Contract No. T200911302.01  
Federal Aid Project No. NH-2015(22)  
US 301 & SR 1 Interchange  
New Castle County

Enclosed is Addendum No. 2 for the referenced contract consisting of the following:

US 301 & SR 1 INTERCHANGE

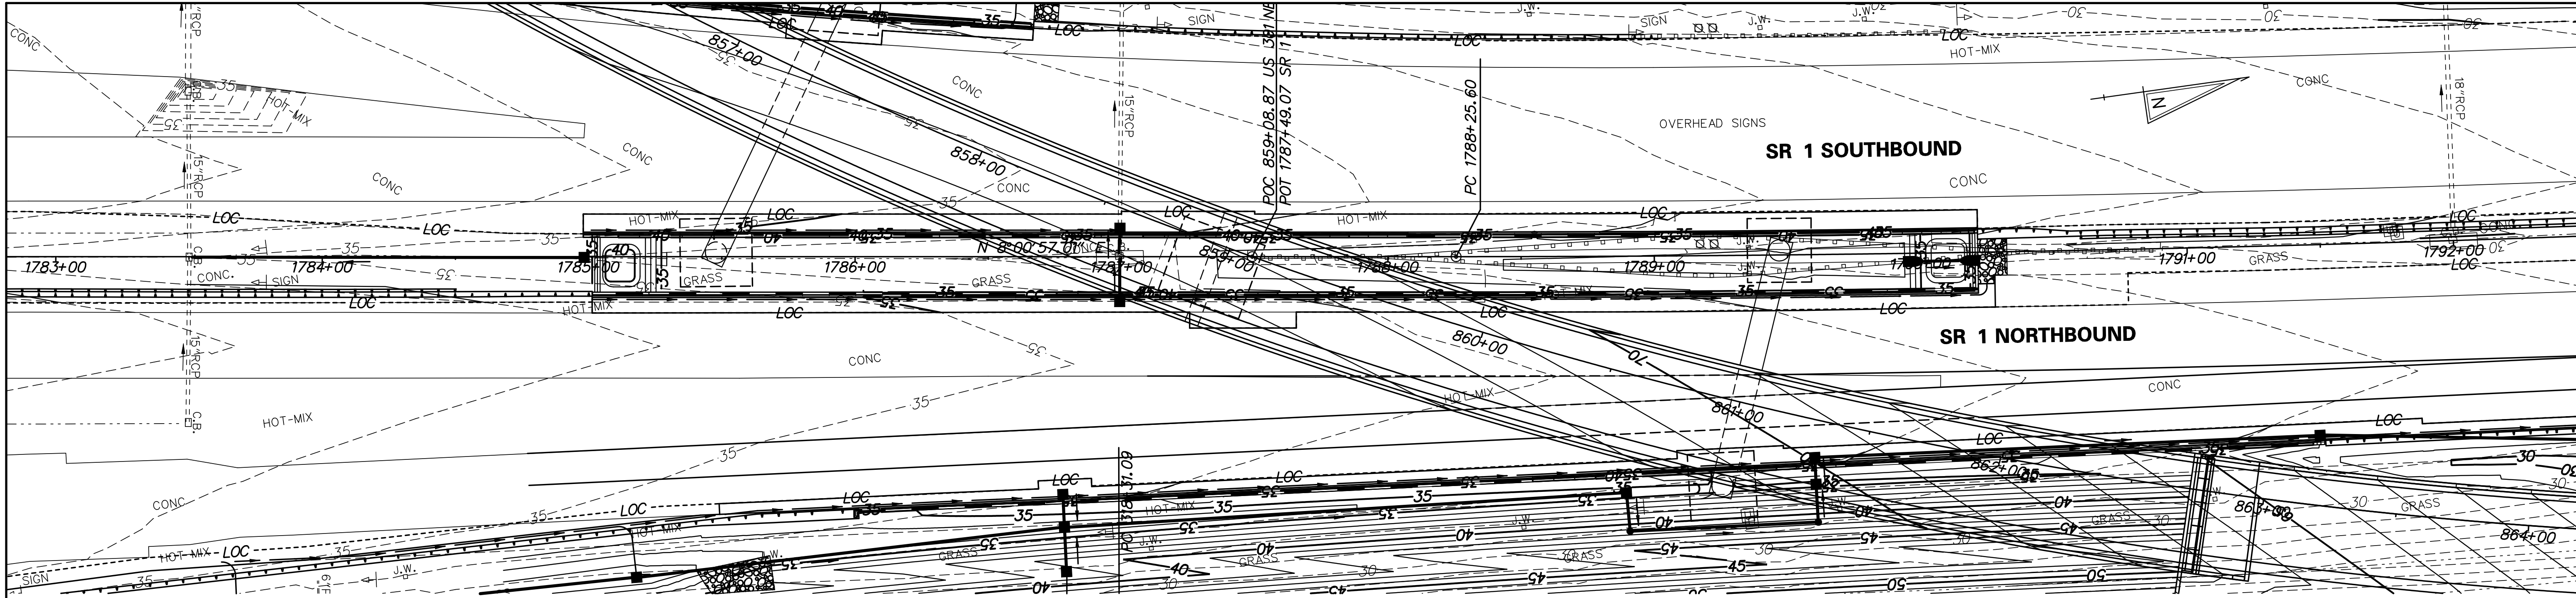
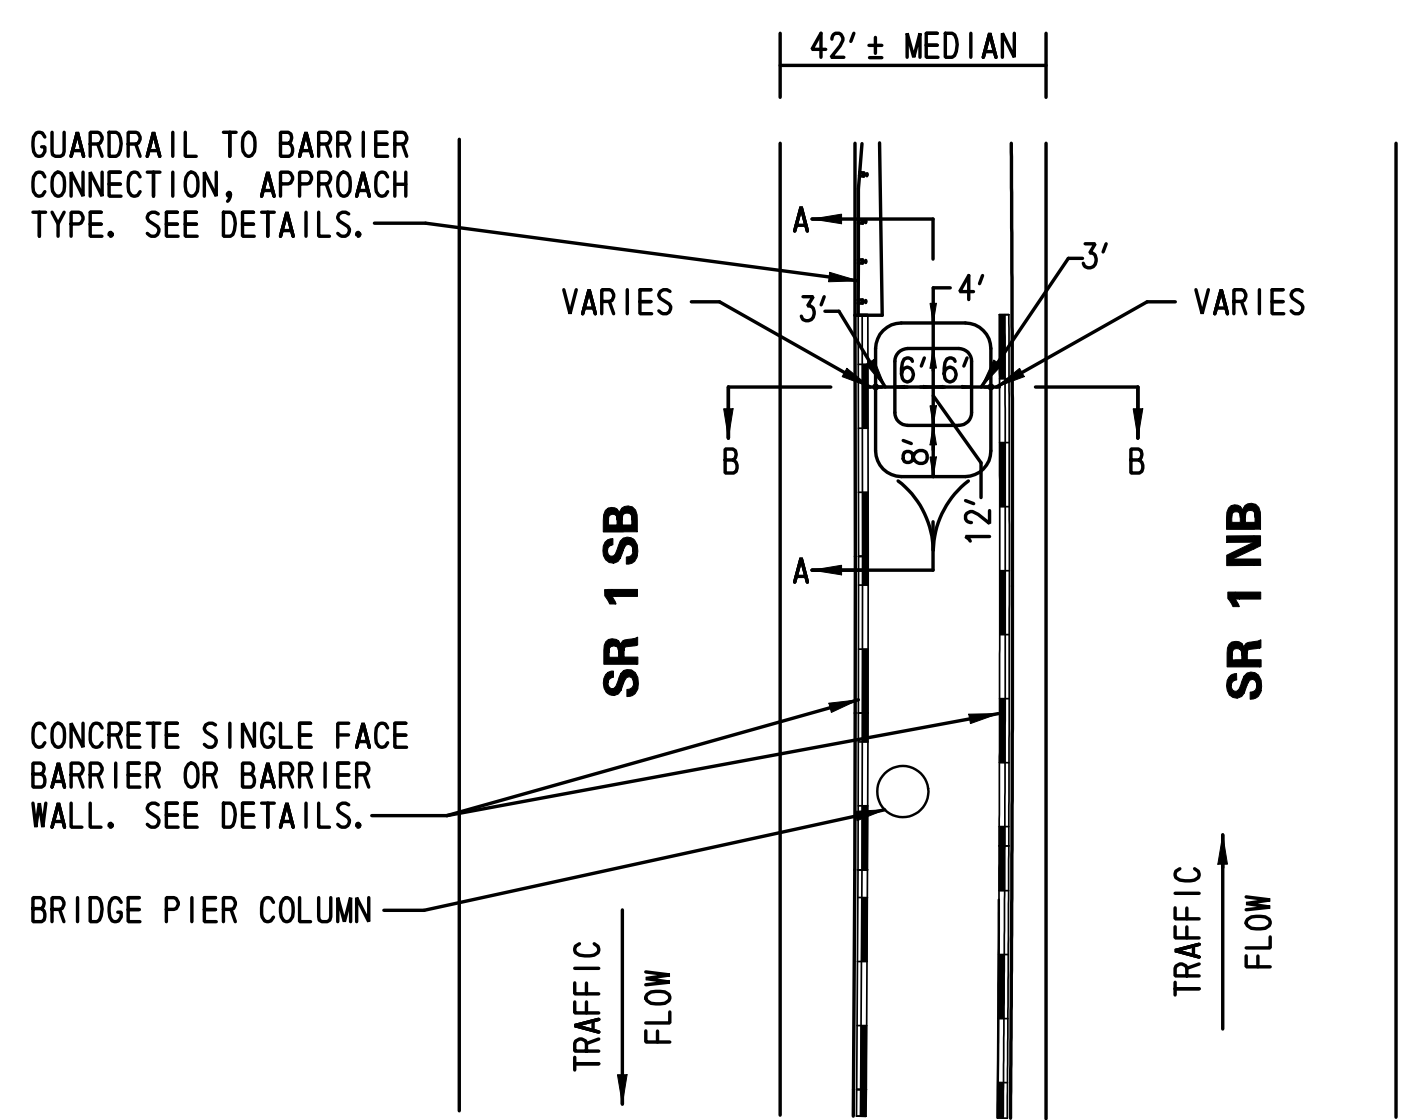
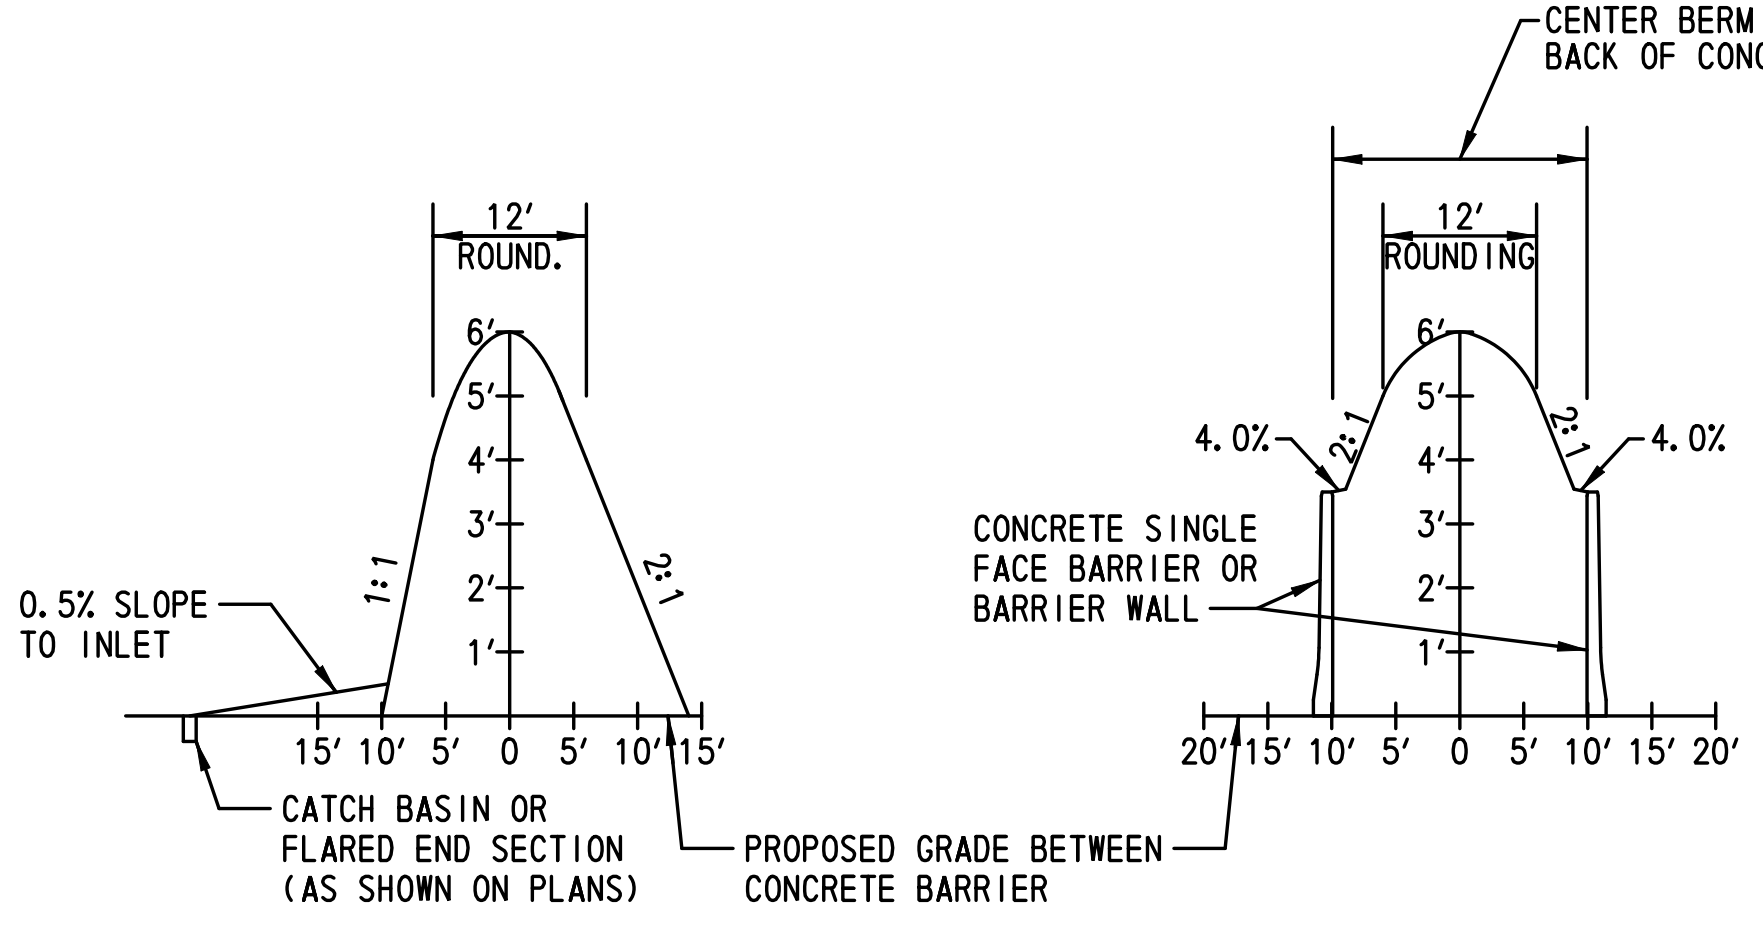
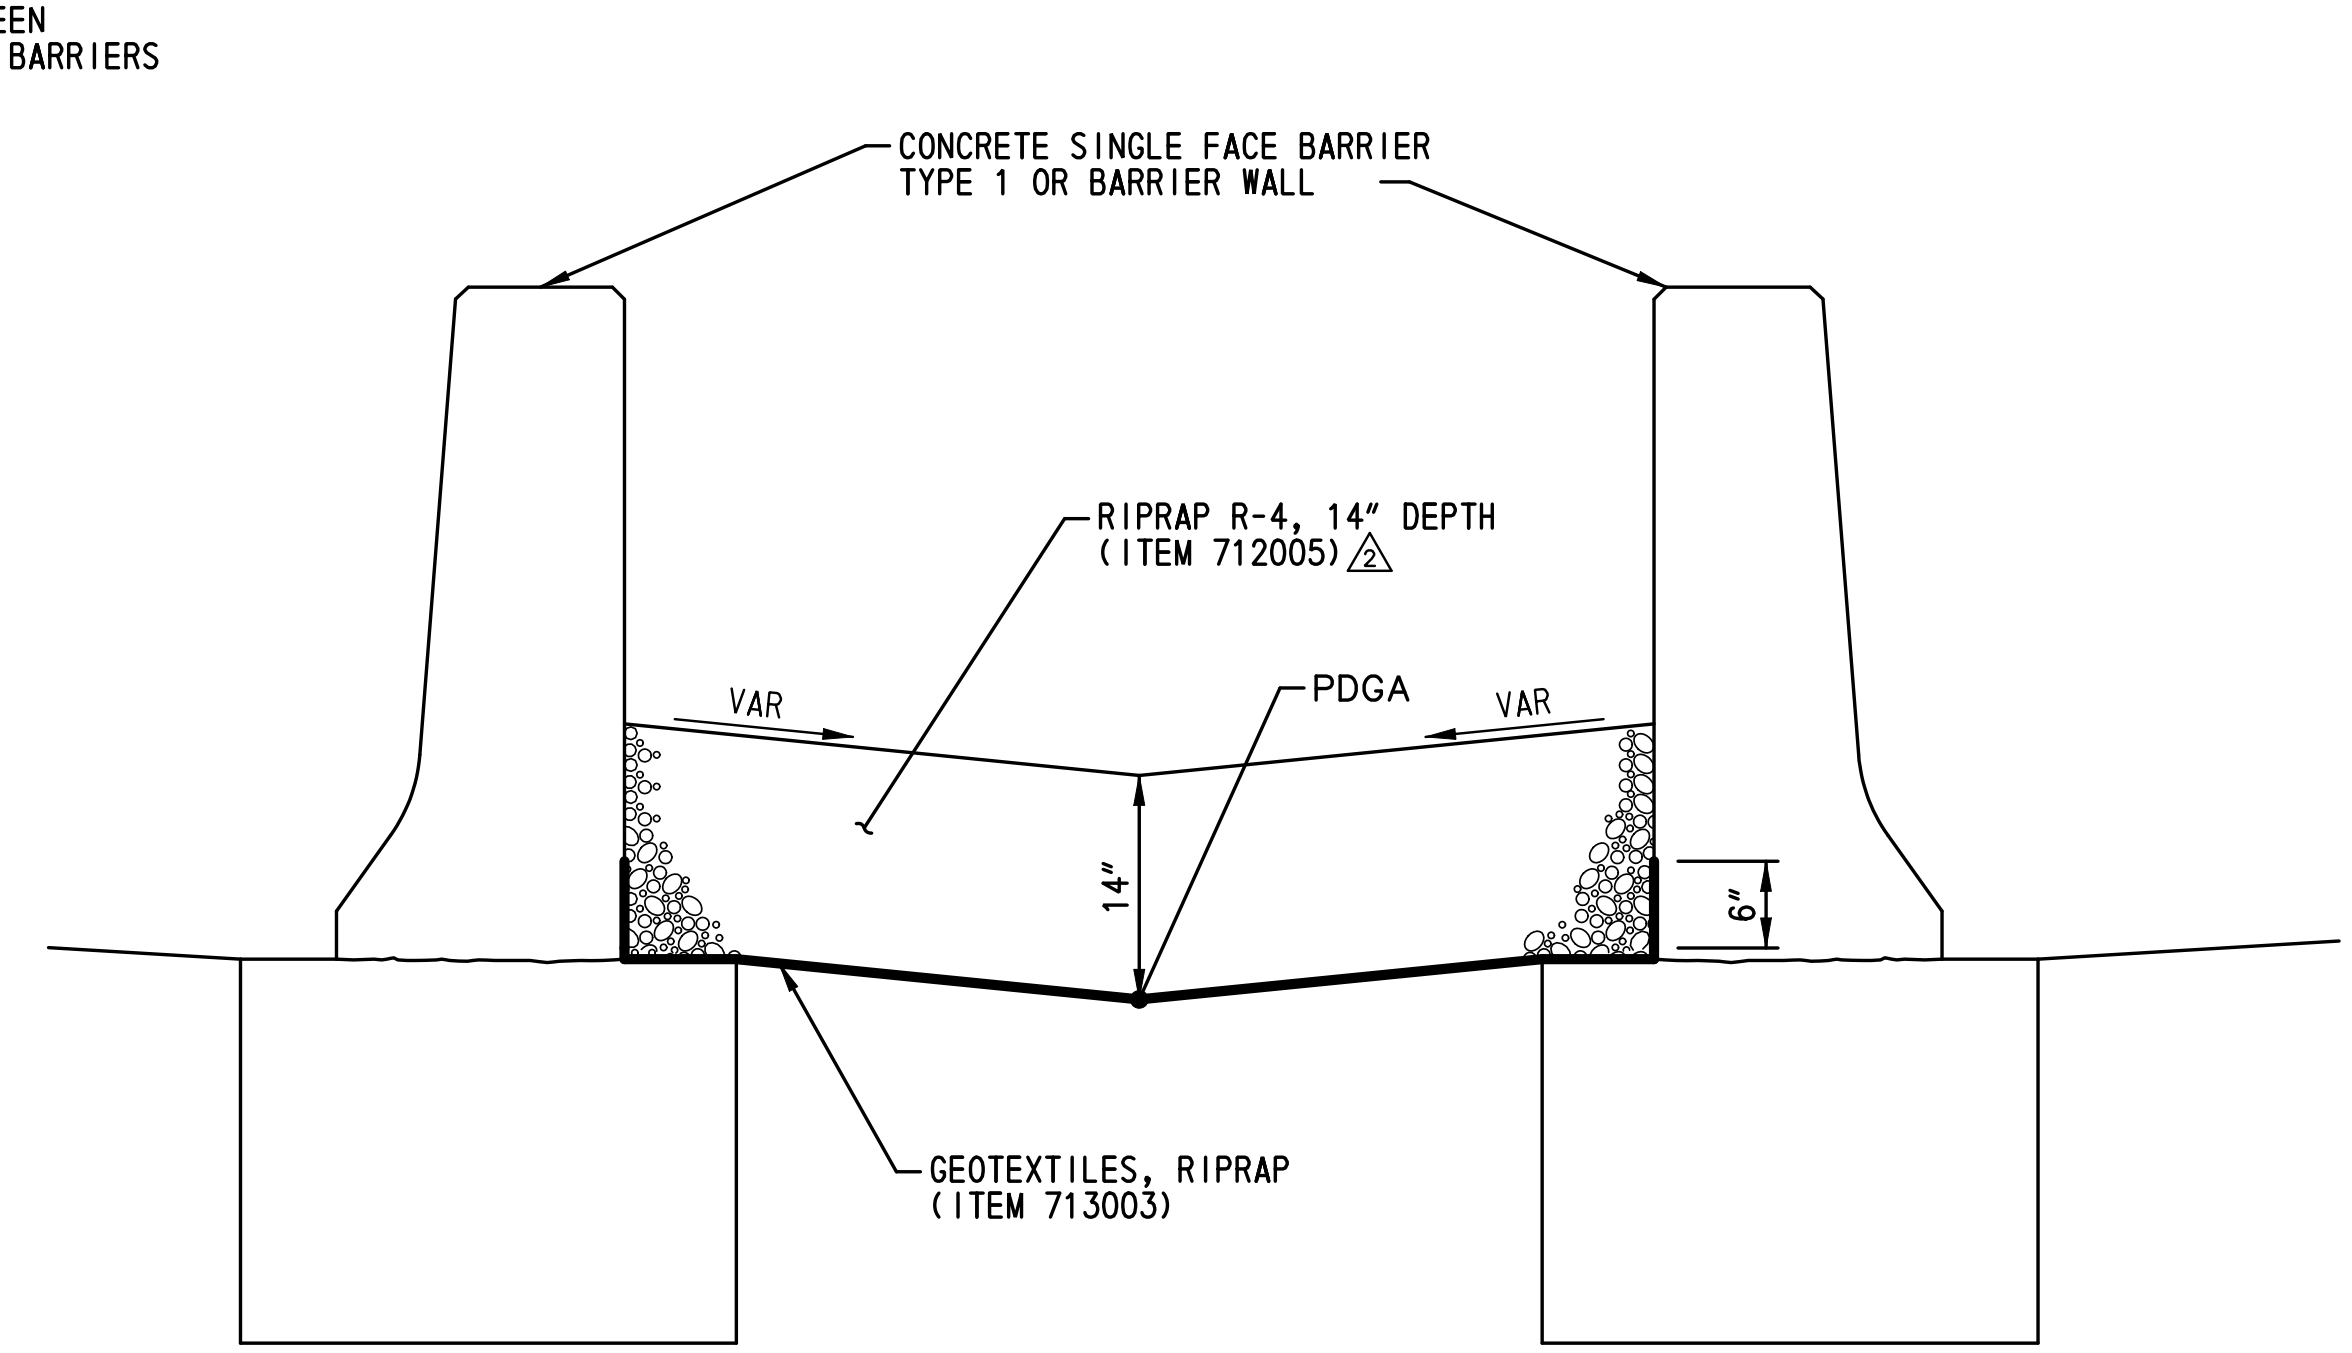
ADDENDUMS / REVISIONS	
REVISED ITEM NO. AND ADDED DIMENSIONS:	
BRT/DMG

DT-06
SHEET NO.
89
TOTAL SHTS.
491

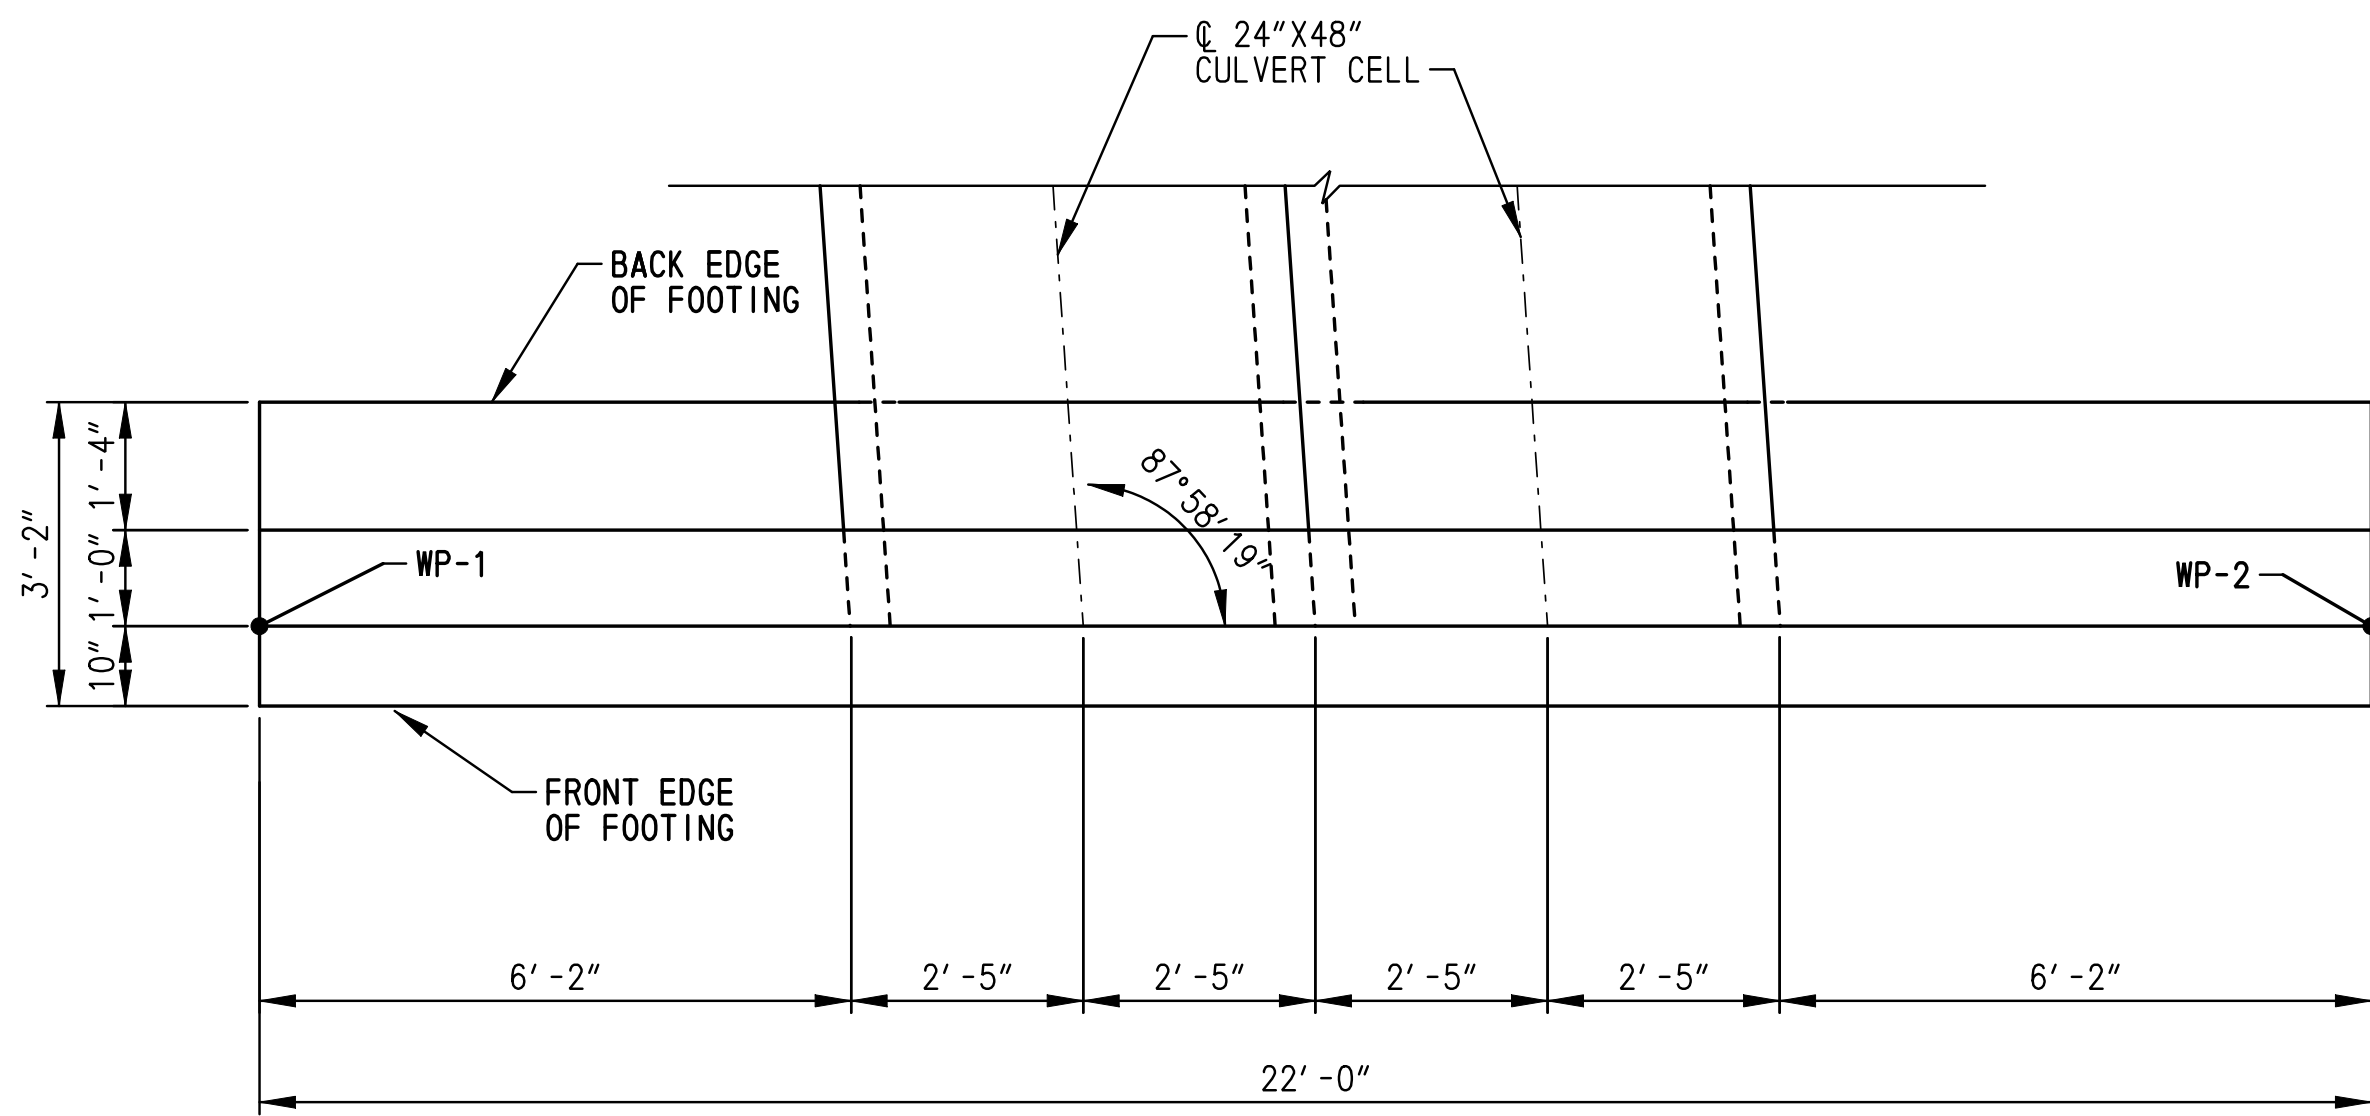
ADDENDUMS / REVISIONS	
REVISED ITEM NO.:	BRT/DMG
